May 07, 2018

RE: PCN Production Transfer for Acquired ON Semiconductor Automotive TVS Diodes SMB (DO-214AA) and SMF (SOD123)

Device Marking Change: following production transfer into our Wuxi, China site.

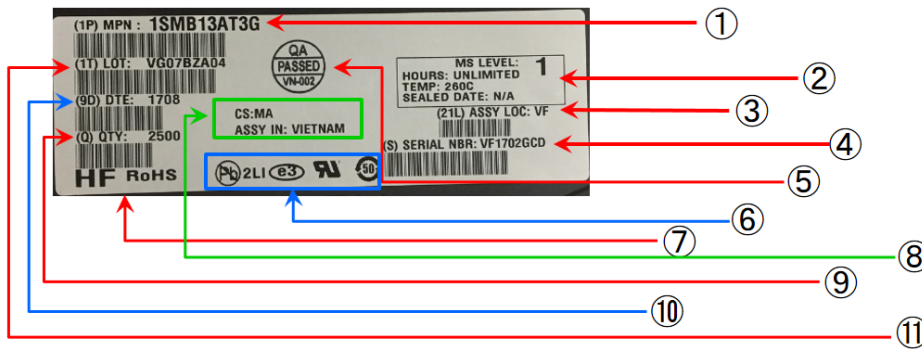
Package	SMA	SMB	SMC	SMF (SOD123 - FL)
Existing (ON)				
Modified (LF)	 XXXX = Device Code Y = Year M = Month A = Assembly Location WW = Lot Code			 XX = Device Code Y = Year M = Month A = Assembly Location WW = Lot Code
Modification Items	1. Intergrat SMA, SMB and SMC using same marking diagram. 2. Use five digits trace code for better traceability. 3. Remove Pb-free dot. 4. Change polarity band quantity from three to one.			1. Change marking from one line to two lines. 2. Use five digits trace code for better traceability. 3. Remove Pb-free dot. 4. Change polarity band quantity from three to one.

Note: Polarity band is only for uni-directional components.

Current label format:

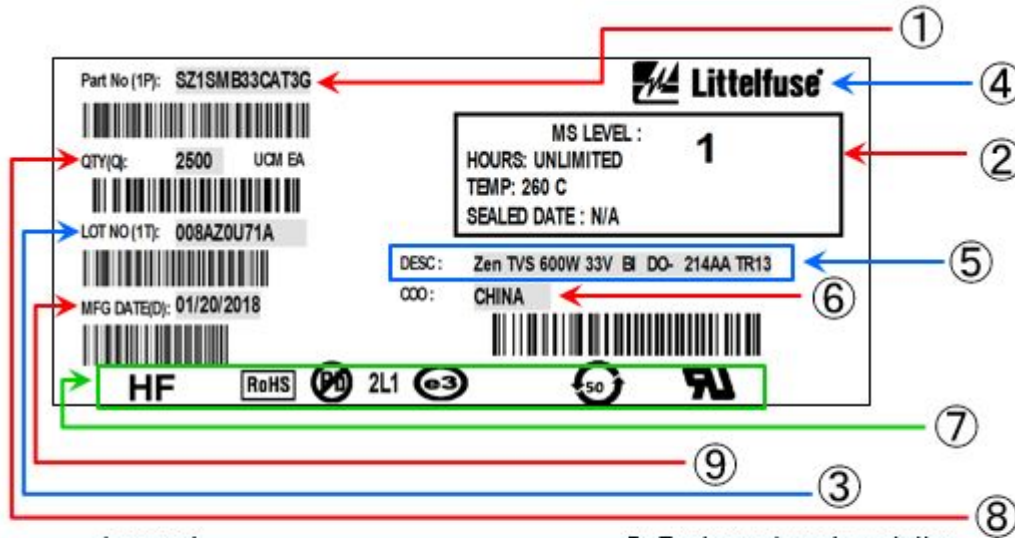
New label format: following production transfer into our Wuxi, China site.

- Legend:
- 1. Part number
- 2. MSL level
- 3. Lot number
- 4. Littelfuse logo
- 5. Part number description
- 6. Assembly site
- 7. Compliance logo
- 8. Quantity
- 9. Manufacturing date
